Reference 24/0096/MFUL

Proposal Proposed construction, operation and maintenance of a Battery Energy Storage System (BESS) with associated infrastructure and works including highway access, landscaping and biodiversity enhancements.

RECOMMENDATION: Approval with conditions

Figure 1 - Priority grassland and woodland habitats within proximity to the site

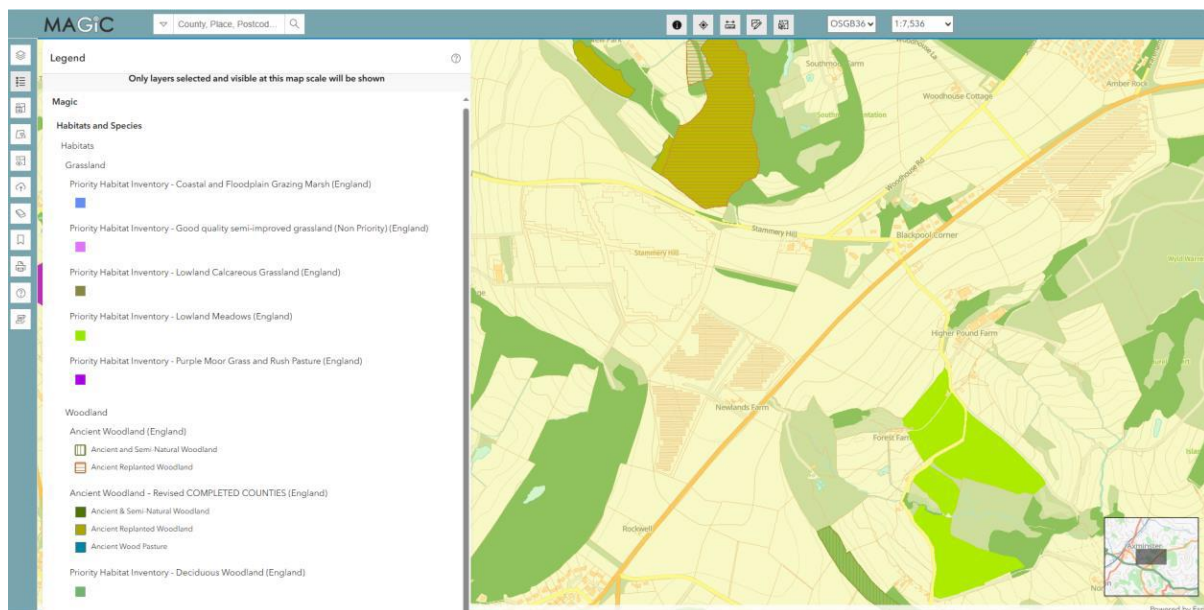
The west boundary hedgerow forms a prominent landscape feature connecting a large area of ancient semi-natural woodland to the north and large area of broadleaf woodland to the south. The hedgerow network on the site also provides habitat connectivity to the south and east to other large areas of woodland and priority grassland habitats (refer to Figure 1).

Figure 3- Aerial image of site showing alternative access arrangements to minimise tree and hedgerow loss

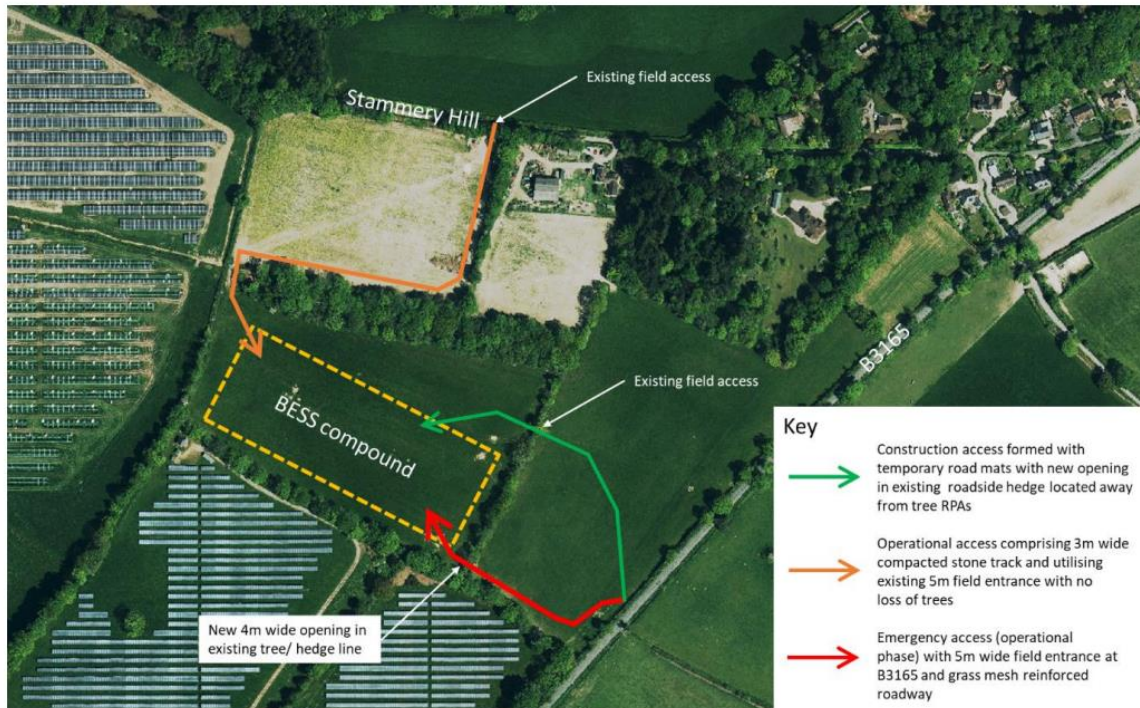
The proposed access arrangements are likely to give rise to significant, localised adverse landscape and visual impacts which could be avoided by alternative provision, as illustrated in the overmarked aerial image in figure 3 below. This would avoid any tree losses with the exception of a new opening required in the southeast corner of the main field where the clearance of a single ash with significant die-back symptoms would be required.
